Project Gertrude Street (182-186), North Gosford

File PKA12382 R02v2 Addendum to DA Acoustic Report R01v1 dated 11th October 2022.docm

Re: Addendum to DA Acoustic Report R01v1 dated 11th October 2022

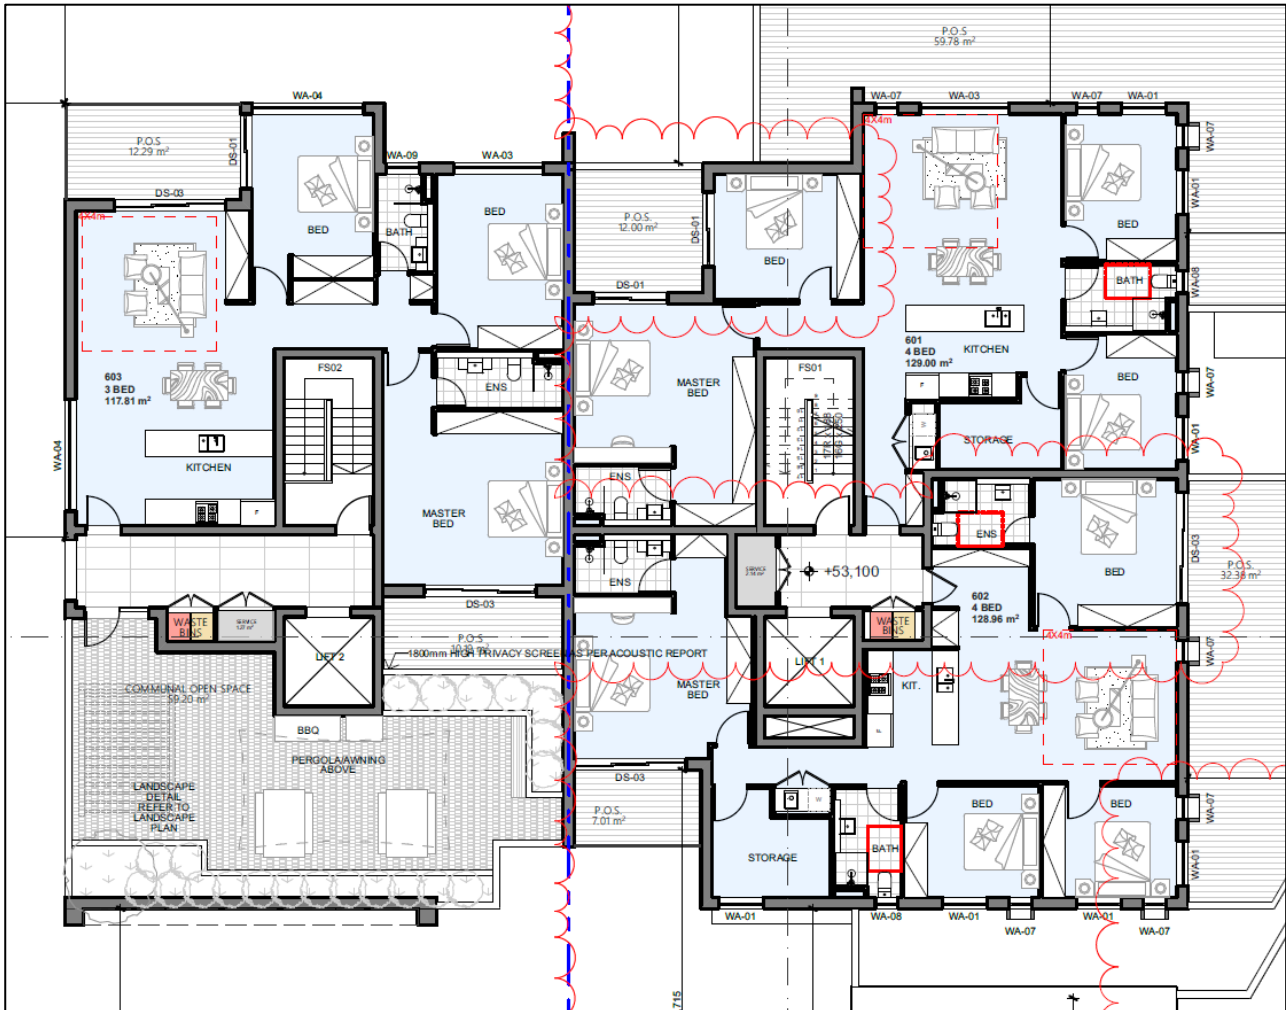
RFI: *The bedrooms of apartments 601 and 602 directly adjoin the rooftop communal open space and the bedrooms of apartments 205 and 207 and POS of apartment 205 are located above the driveway to the basement carpark. Provide an updated Acoustic Report which considers noise impacts to bedrooms and POS and if required, recommendations for noise mitigation.*

Based on the review of the current layout of the architectural plans, the Master Bedroom of Apartments apartment 602 and 603 are directly adjacent to the proposed communal open space and Apartment 601 is now acoustically isolated from this area.

The wall of Master Bedroom of Apartment 603 comprises of a glazed doors leading to their POS. To mitigate any noise impact from the communal area, PKA recommends that this door be upgraded to minimum R_w32 acoustic system (typically 6mm lam glass with perimeter silicon acoustic seals) in addition to the 1.8m proposed solid acoustic privacy screen in the P.O.S. It is recommended that this screen is built using a material that achieves a minimum $R_w 20$ (readily achieved with standard fibre-cement sheeting or Colorbond fencing), is of solid construction with no gaps or penetrations within the fence or at the structural bases.

Although the private open space of the balcony is located adjacently to the communal area, it is separated by a solid masonry wall that will significantly shield the noise impact from the use of the common spaces.

In addition to the above, it is recommended that the building management create procedures for the use of the communal space be limited to the hours of 7am to 9pm to prevent additional noise generation during the night-time period and provide acoustic privacy to the adjoining apartment during quiet hours.

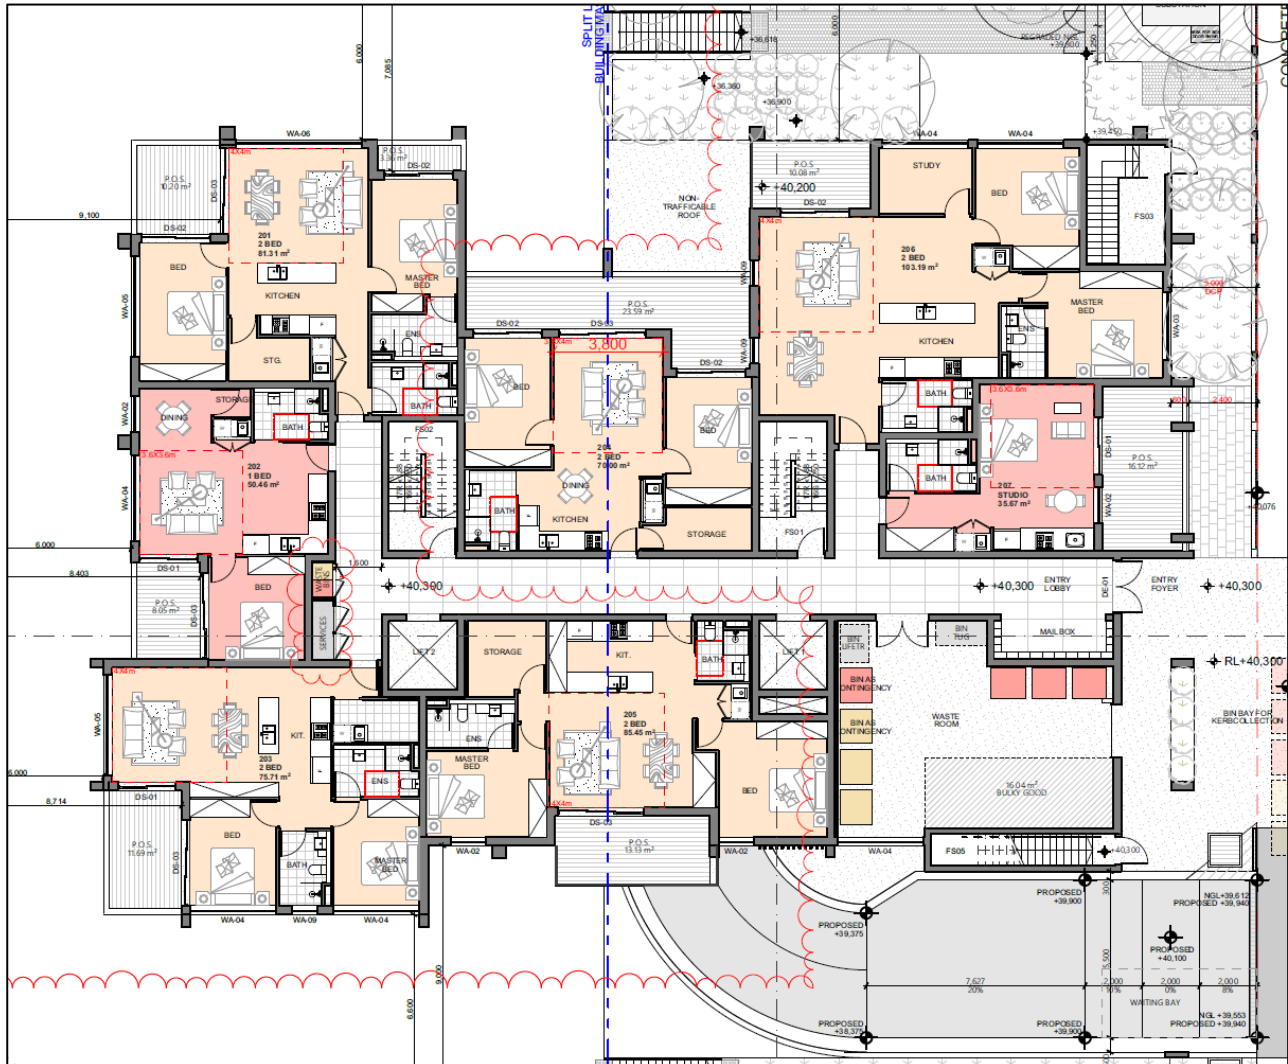
Carpark Noise to Apartments 205 and 207:

Generally, there are no acoustic provisions within guidelines to address noise intrusion from the use of the apartment driveway to within the building externally. However, as a general guide, the internal levels of the *AS2107:2016 Acoustics - Recommended design sound levels and reverberation times for building interiors* may be considered which provide indoor design levels of 35-40 dB(A) for internal habitable spaces. Averaged over periods of day and night acoustic compliance with these levels will be readily achieved with standard construction with no additional mitigation measures required.

For additional comfort, at the discretion of the client, the glazing on these façades may be upgraded to R_w 32 acoustic rated systems (typically 6mm lam glass with perimeter silicon acoustic seals) This

To mitigate noise from the carpark area to the habitable areas directly above, through the slab, the Building Code of Australia requires the separating wall to achieve a sound insulation rating of R_w 50 which is readily achieved by the proposed concrete slab.
